**Machine List Report
Genie Campaign Bulletin**

140002 - 48V RELAY

Safety Notice

Subject: Relay Failure

Illustration 1

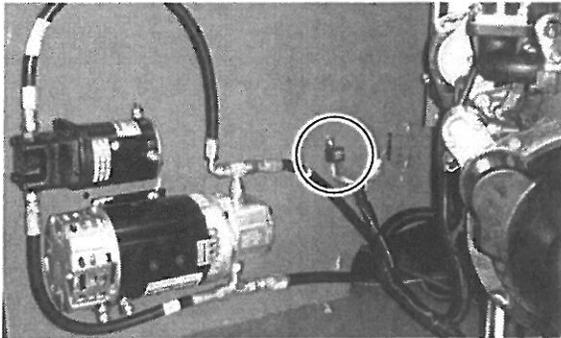
This Safety Notice requires replacement of the affected relays installed on the machines listed on page 5.

Alternator Relay, CR16
(Engine Side, Bi-Energy models only)

Model	Power Option	Alternator Relay Kit	Work Lights Kit	Drive Lights Kit
Z-30/20N & Z-30/20N RJ	DC	Not Applicable	823951	824045
Z-34/22 & Z-34/22N	DC	Not Applicable	823951	824045
Z-45/25 & Z-45/25J	DC	Not Applicable	823951	824045
Z-34/22	Bi-Energy	161949	823951	824045
Z-45/25 & Z-45/25J	Bi-Energy	161948	823951	824045
Z-45/25 UAFSP	Bi-Energy	161948	Not Applicable	Not Applicable

Illustration 2

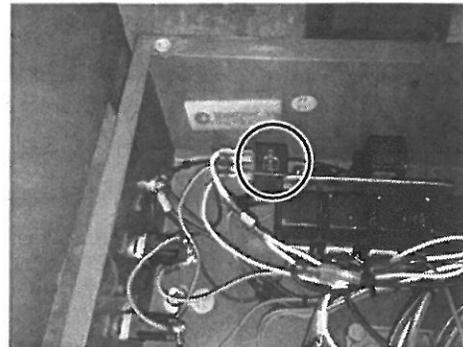
Work Lights Relay, CR45
(Platform Control Box)

Illustration 3

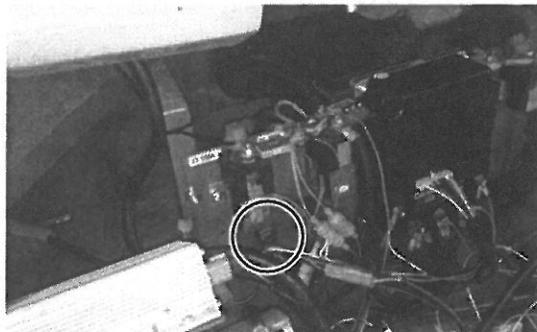
Drive Lights Relay, CR23
(Chassis, Non Steer End)

Illustration 4

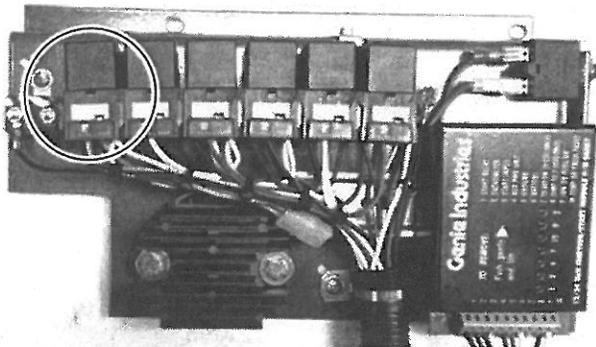
Alternator Relay, CR16
(Engine Side, Bi-Energy models only)

Illustration 5

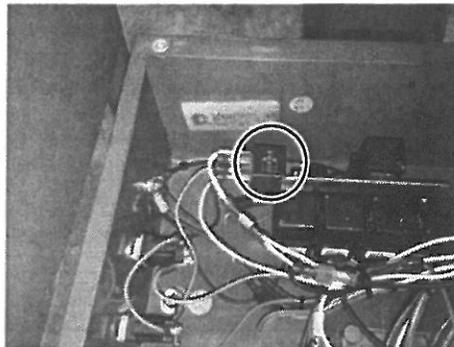
Work Lights Relay, CR45
(Platform Control Box)

Illustration 6

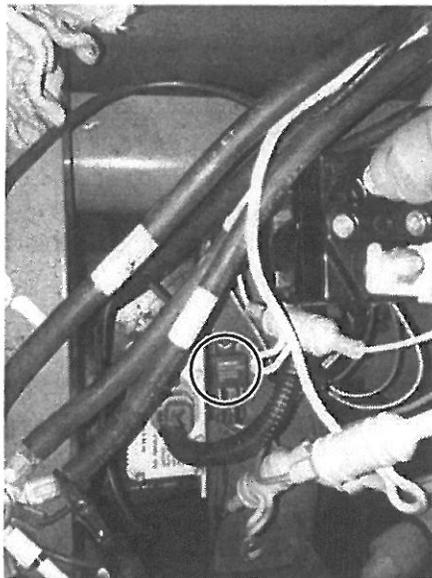
Drive Lights Relay, CR23
(Chassis, Non-steer End)
